CAIRNS SHIPPING DEVELOPMENT PROJECT

PILING ACTIVITY UNDERWATER NOISE

Definition of Project Observation and Exclusion Zones for Marine Fauna Management

Piling Underwater Noise Report

Figure 1: Proposed upgraded channel and swing basins (from revised draft EIS Chapter A3)

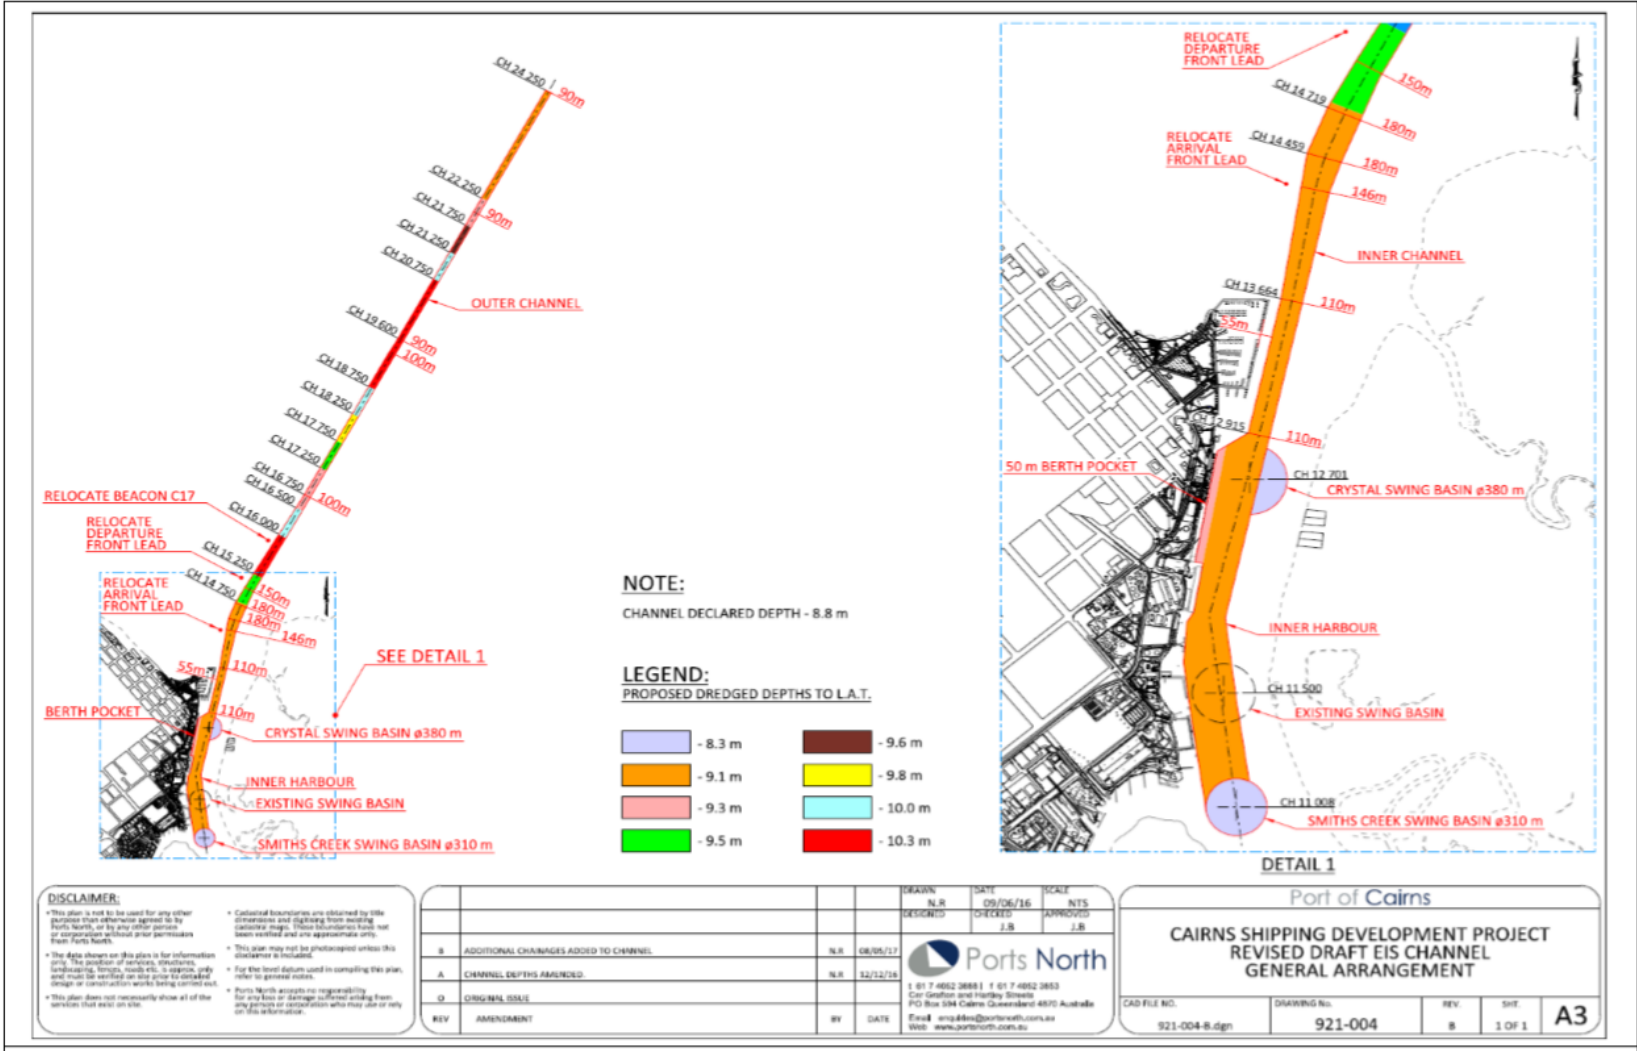
2.1	Project description	It would be helpful for the reader to include a site plan showing high level information regarding the project study area and piling activating locations. While this information may exist in other documentation, it would be appropriate to include within this section of the report also.	Include a site plan show piling activity locations.

Figure 12: Updated piling peak, SPL and SEL source levels at 1 m

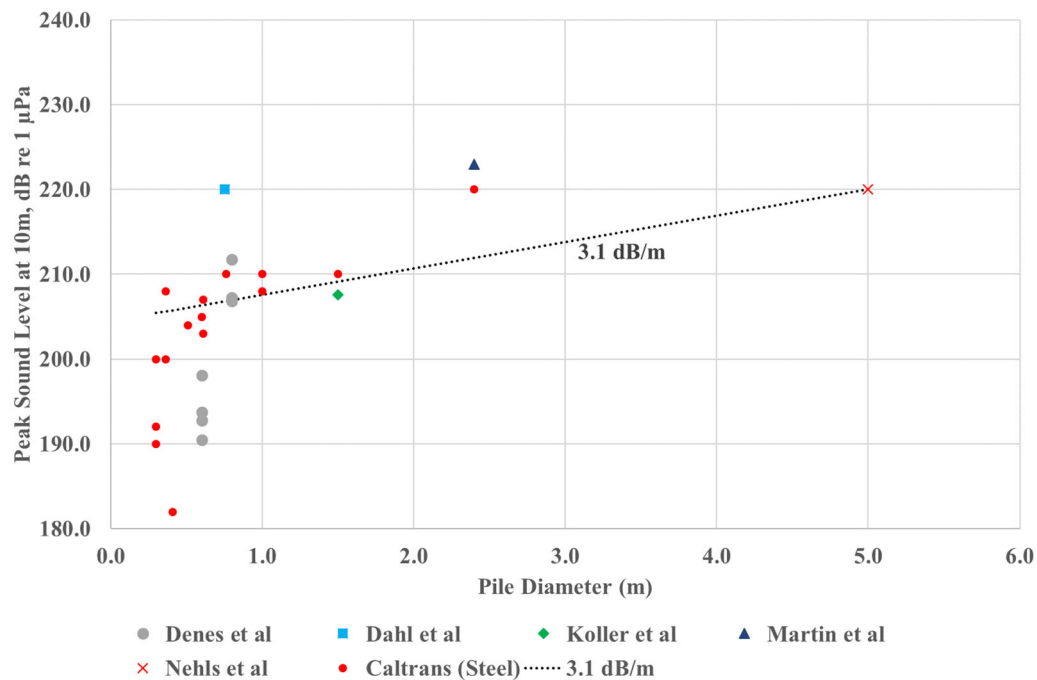
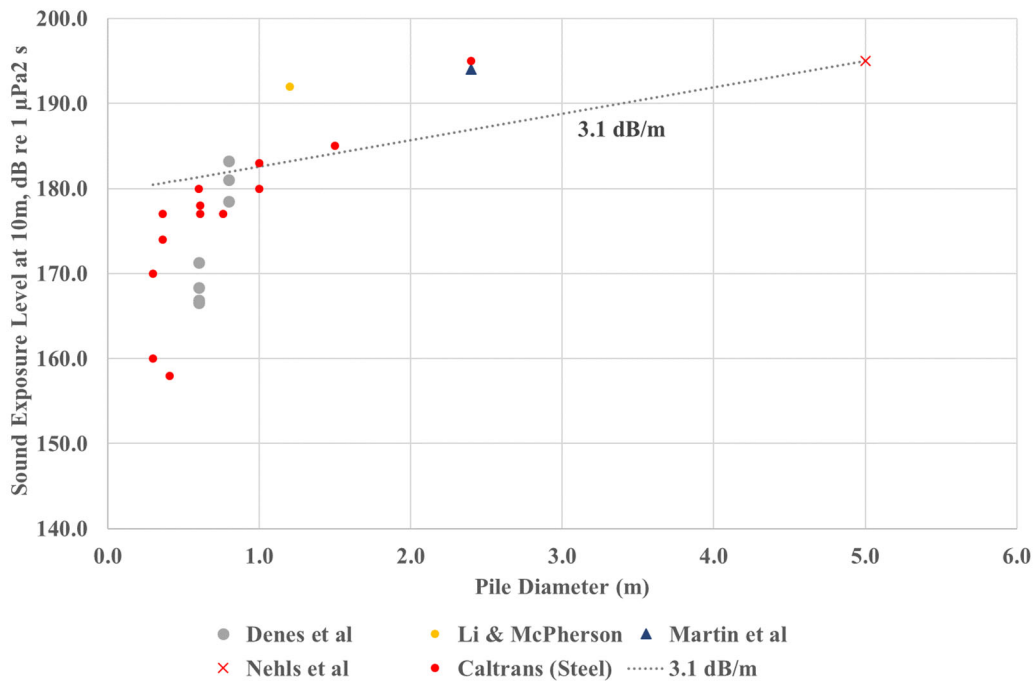
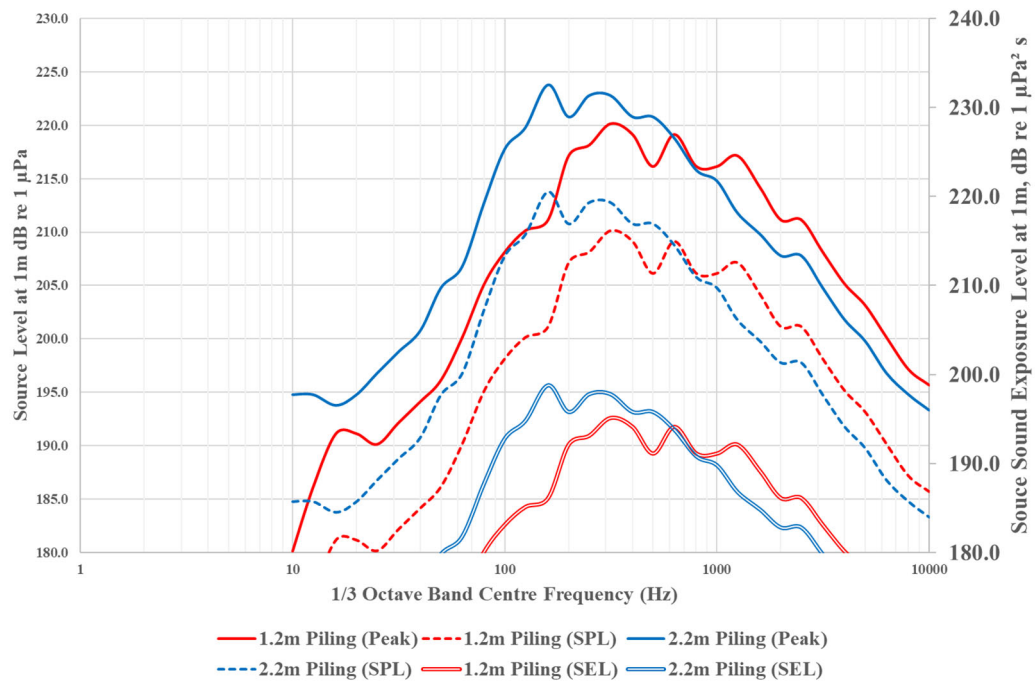
Report section	Description	MDA comment	Recommendation or action
4.4	Source Levels for Marine Piling	<p>This section presents a range of data for piling source noise levels for different pile diameter sizes. To determine the source levels for the assessment the same approach has been used as in the Draft EIS noise report 2014 (measured levels for 5 m piles, adjusted down for smaller pile diameters, based on a linear relationship). A 10dB safety factor has been added to the derived levels.</p> <p>The approach used results in piling source noise levels that could be considered to be at the upper end of the range for the respective pile sizes. The inclusion of a 10dB safety factor seems unnecessarily high given the impact such a factor could have on zone distances. If there were particular concerns about the linear relationship method of noise level derivation, some commentary should be provided and the 10dB adjustment justified. While we would typically encourage the use of a conservative approach, in this case the levels could be considered unrealistic when compared to source levels measured from similar piling operations and could result in management zone distance that are greater than necessary. Provisions for early monitoring have been recommended in the report so piling noise levels could be confirmed at that stage and zones adjusted accordingly.</p> <p>We broadly agree with the statement that levels roll-off at frequencies below 100 Hz and consider the spectra used in the assessment to be suitable.</p>	Reconsider piling source levels.

Figure 13: Source locations for piling (from draft EIS)

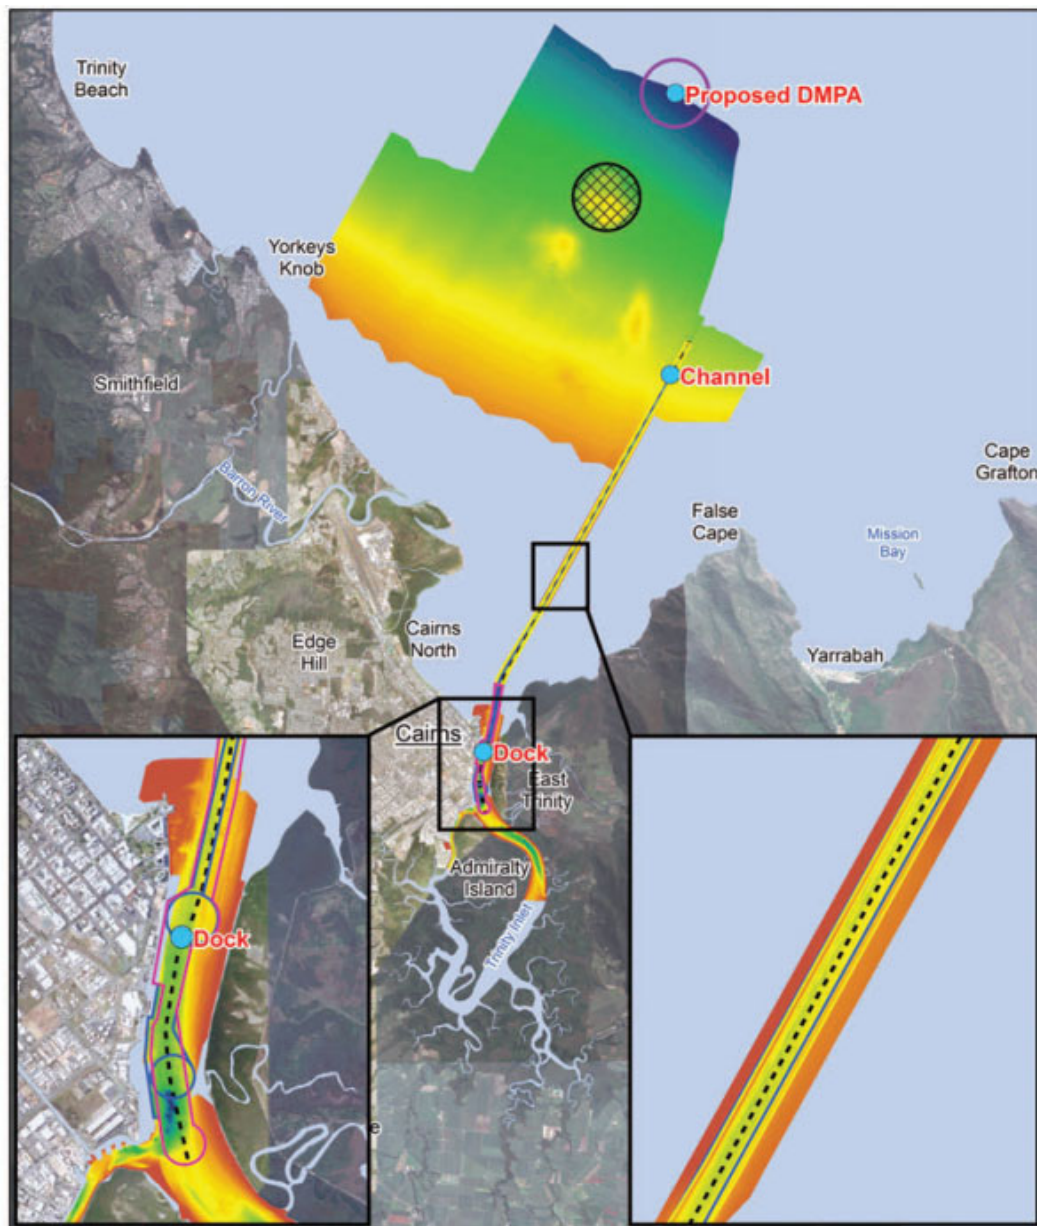
5.1	Source locations	The assessment makes reference to the Draft EIS noise report 2014 for source locations however that report does not specifically state location coordinates. The only information provided regarding the source locations in the Draft EIS noise report 2014 is the site plan in Figure D7.7.6.1a.	Provide source location coordinates

Figure 14: Bathymetry for wharf piling

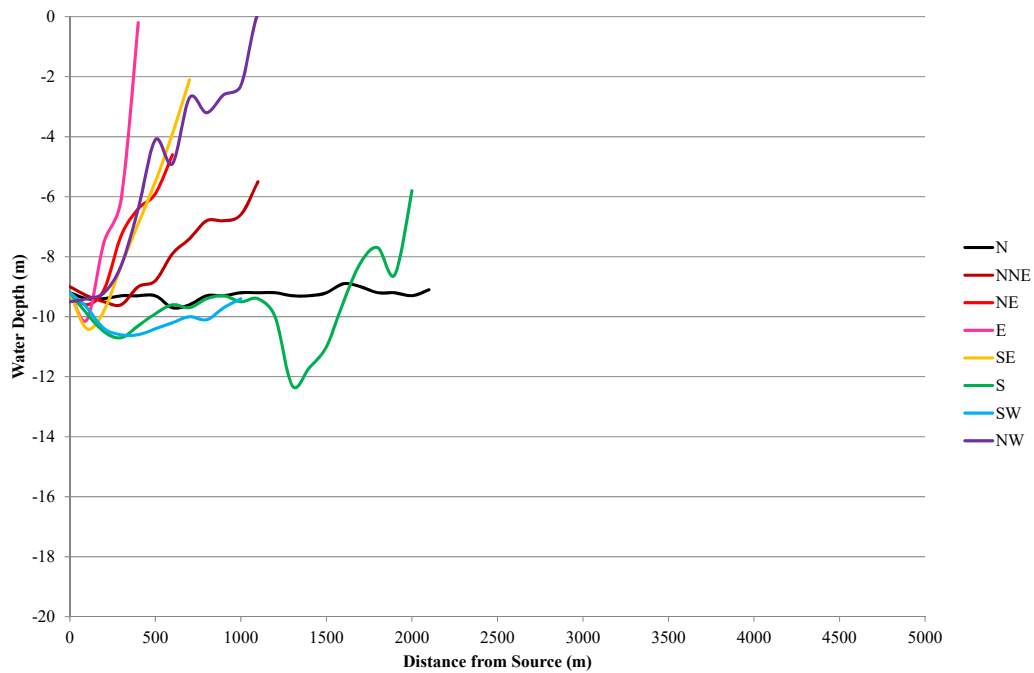
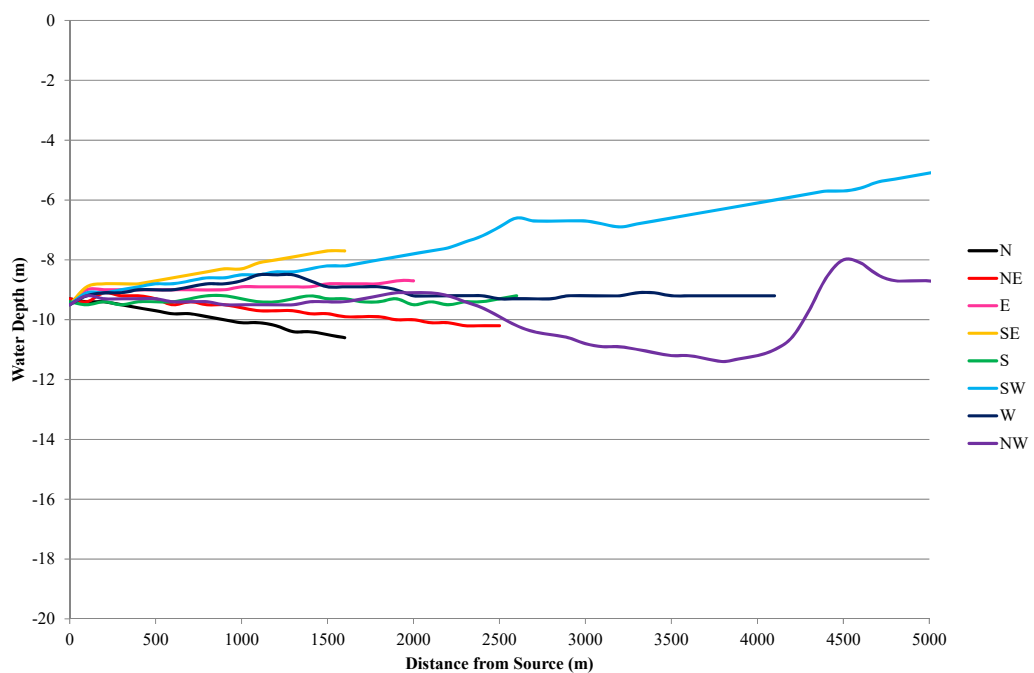
5.1	Bathymetry	The assessment makes reference to the Draft EIS noise report 2014 for bathymetry information. That report states that 'Bathymetry data was obtained from the Geoscience Australia 250 m electronic bathymetry grid.' Our understanding is that the Geoscience data would not provide sufficient depth resolution for modelling purposes for the wharf area and shipping channel. The results suggest that additional bathymetry data has been used (plots in Figure D7.7.6.1a. appear to show detailed bathymetry was available) but no details are provided.	Clarify data sets used for bathymetry.
